**CONWAY**  
HISTORIC DISTRICT COMMISSION  
STAFF REPORT

**5:30pm • May 29, 2018 • City Hall**

**ROBINSON HISTORIC DISTRICT  
CERTIFICATE OF APPROPRIATENESS REVIEW  
CLARK NEW PARKING LOT  
1517 CALDWELL STREET**

**OLD CONWAY DESIGN OVERLAY DISTRICT  
CERTIFICATE OF APPROPRIATENESS REVIEW  
MCKINNEY REMODEL AND ADDITION  
923 PARKWAY STREET**

**Elevations**

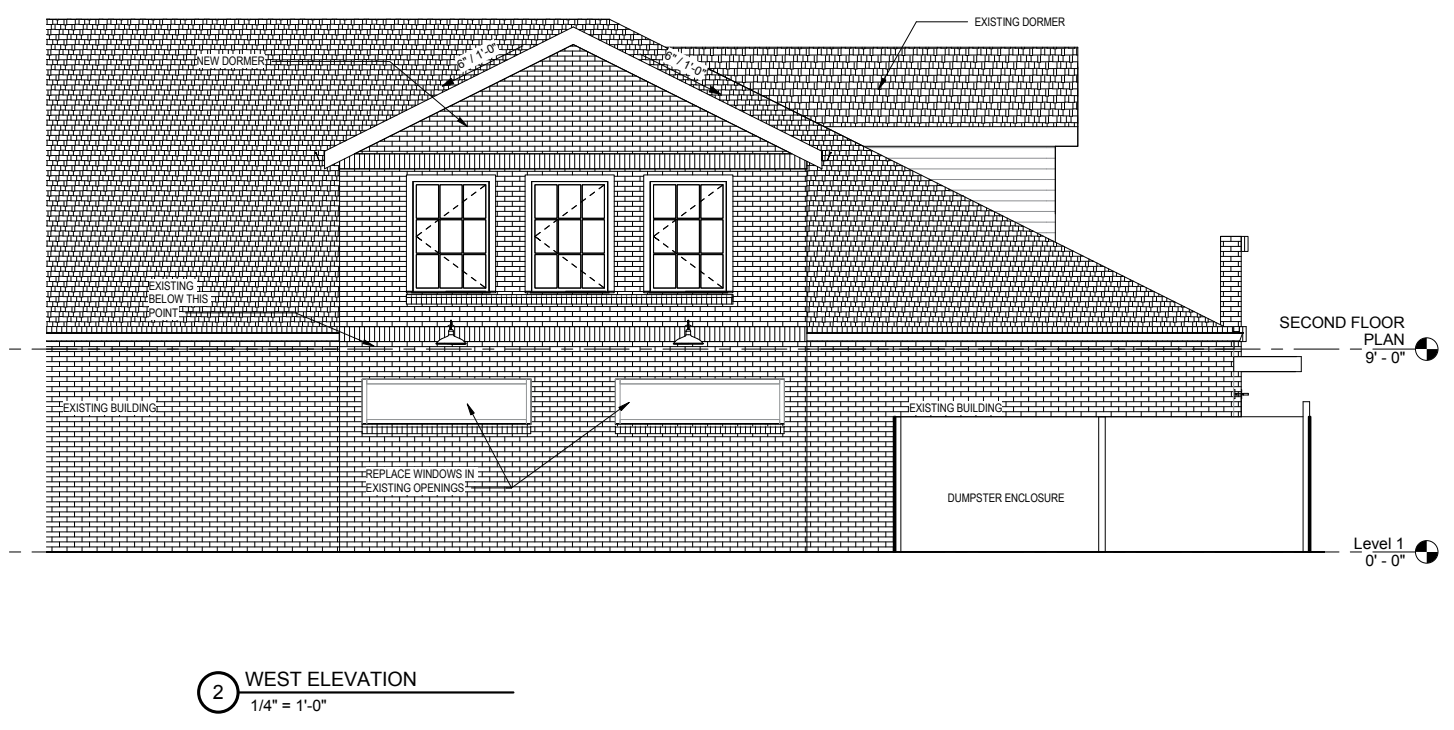
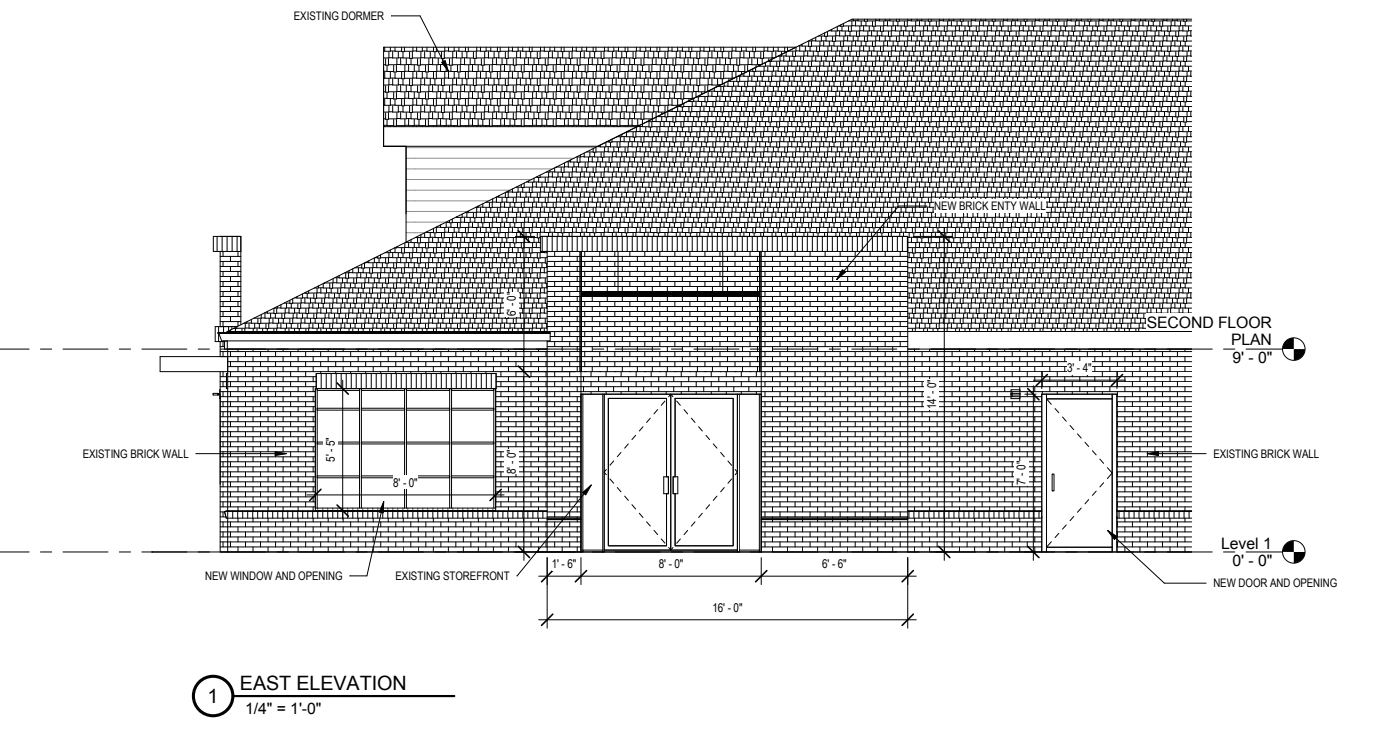
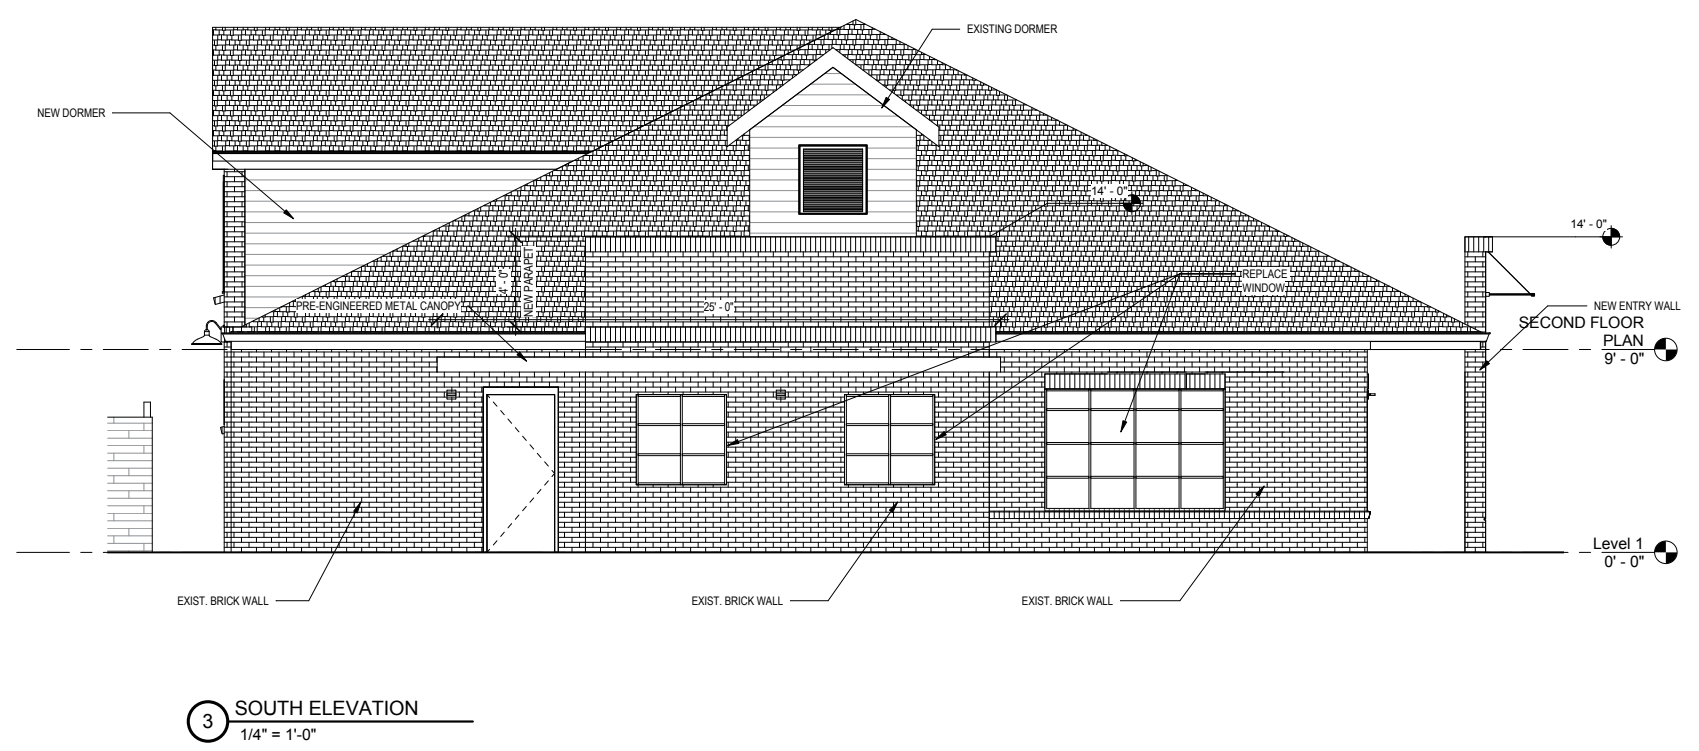
**Fences.** No fencing is proposed. A fenced dumpster enclosure is shown on the west elevation. If a dumpster enclosure is used, per development review regulations, it must be a masonry enclosure meeting Sanitation Department specifications. Roll carts will not require an enclosure.

**Façade, wall area, rhythm.** Facades shall be compatible with surrounding historic structures in proportion of wall to opening area. The proposed remodel adds additional windows and doors to the east and south elevations. New windows will also be placed on the west 2nd story. These windows and doors will add additional breaks in an otherwise blank facade.

**Style.** The style should compliment the existing and area structures. The structure is a suburban style office structure that is somewhat out of character with surrounding traditional downtown structures. The proposed brick wall elements add a contemporary vertical element that possibly blends better with traditional downtown structures.

**Doors and windows.** Two new private doors are also proposed for entry to a kitchen (south elevation) and upstairs apartment (east elevation). The proposed windows include window dividers. It is assumed that these are false dividers. The existing windows throughout the rest of the office structure use false dividers. It may be preferable to match existing windows or possibly go a new direction with no dividers.

**Awnings/Canopies.** When new construction uses awnings, traditional awning designs, materials, and placement should be used. A metal canopy is shown on the south elevation. This canopy provides some additional detailing and provides shelter for the rain for a new kitchen entry door.

**Architectural Details, Siding, and Bricks.** Eaves, brackets, dentils, cornices, molding, columns, trim, etc. The existing structure has few detailing elements. It is clad in brick and has a low angle hip roof accented with decorative dormers. Proposed vertical brick wall elements with a soldier coursing of bricks, along with a canopy, and additional windows add a greater degree of detailing to the structure. However, this detailing will only be on one end of the structure. The large 2nd story dormer shows some form of siding matching existing dormer siding. Typically, siding is a prohibited material in the urban district. However, siding exists and the new dormer is a retrofit to the existing building. Brick veneer on this wall area probably not possible. The applicant can provide additional information concerning the type of proposed siding at the meeting. Another factor is the use of the vertical wall elements. These create a new look and possibly help blend with more historic structures, however, it creates a “one sided” look to the existing office structure.

Some consideration should be given to the vertical brick wall elements. These walls would create a mass that better blends with flat roofed rectangular traditional commercial structures. However, the walls are only being applied to one end of the existing building creating a “one-sided” look. Conversely, The walls help define the entry and add interests to the plain structure.

Staff recommends approval of the new remodel and 2nd story addition with the following conditions:

1. The remodel and 2nd story addition shall be constructed as shown in submitted plans.
2. Dumpster pen shall be constructed from masonry materials matching the structure per Planning development review regulations.
3. New dormer siding material?
4. Window false dividers?

Site Plan

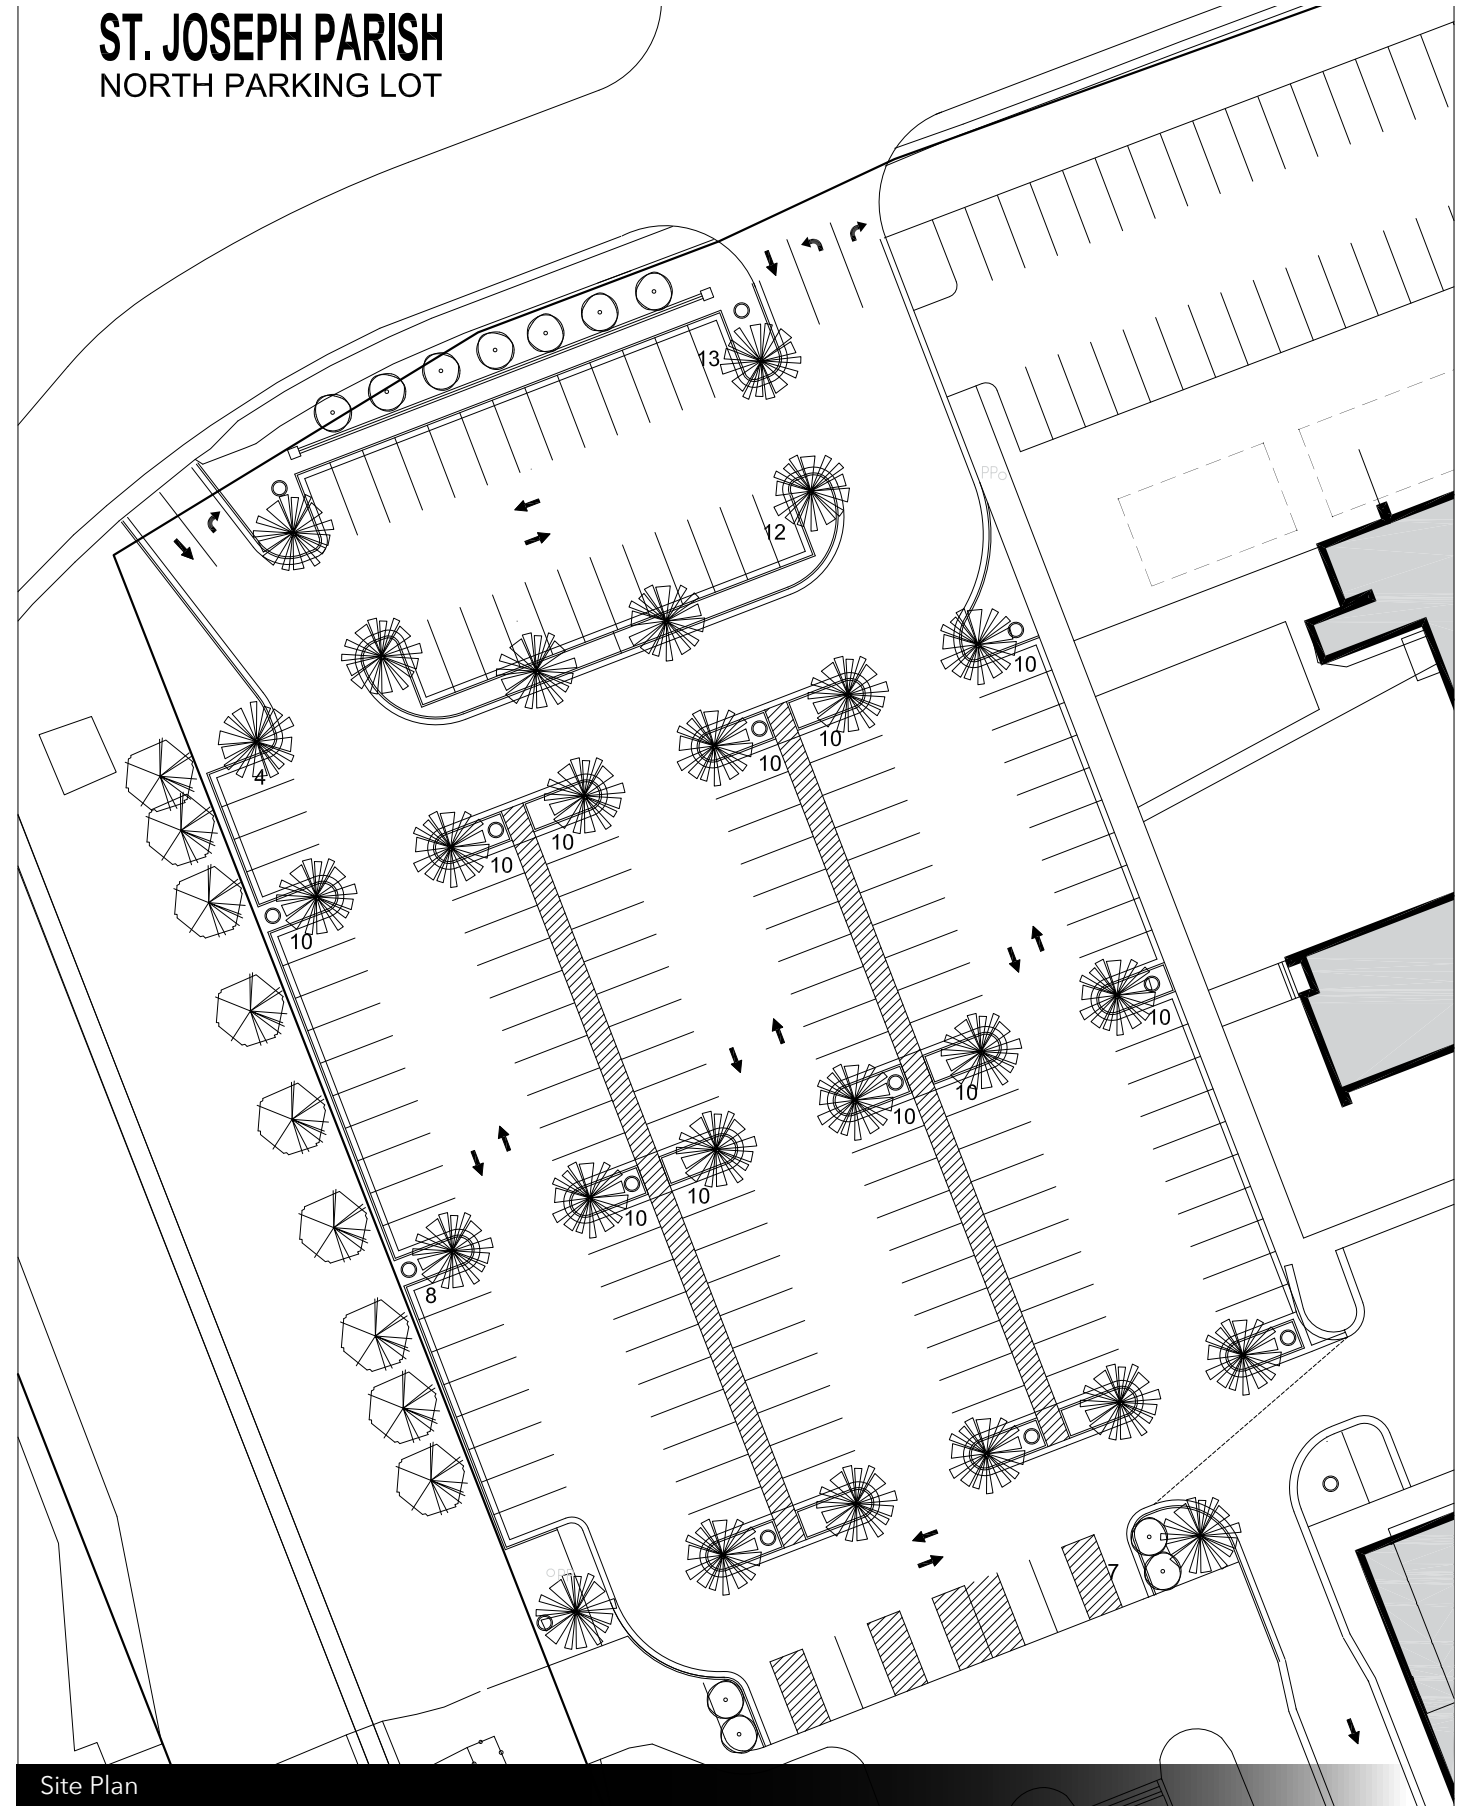
**Fences/Walls.** A screening wall is proposed along the College Avenue frontage to help create a more pedestrian friendly streetscape. The proposed wall is around 3'-10" tall with a 3'-0" ornamental metal fence on top. 7 foot tall brick columns are also proposed to anchor the wall on each end. In the case of this proposed parking lot, a screening wall is required. The proposed brick wall with ornamental metal fencing and brick columns is appropriate for this scale of parking lot.

**Landscaping.** The parking lot appears to meet Planning Department development review standards for landscaping. Tree species are not listed but can be determined as part of Planning Development review.

Staff recommends approval of the new parking lot with the following conditions:

1. The parking lot shall be constructed as shown in submitted plans.
2. Tree and shrub species shall be determined as part of Planning Staff development review.
3. Lighting shall be determined as part of Planning Staff development review.
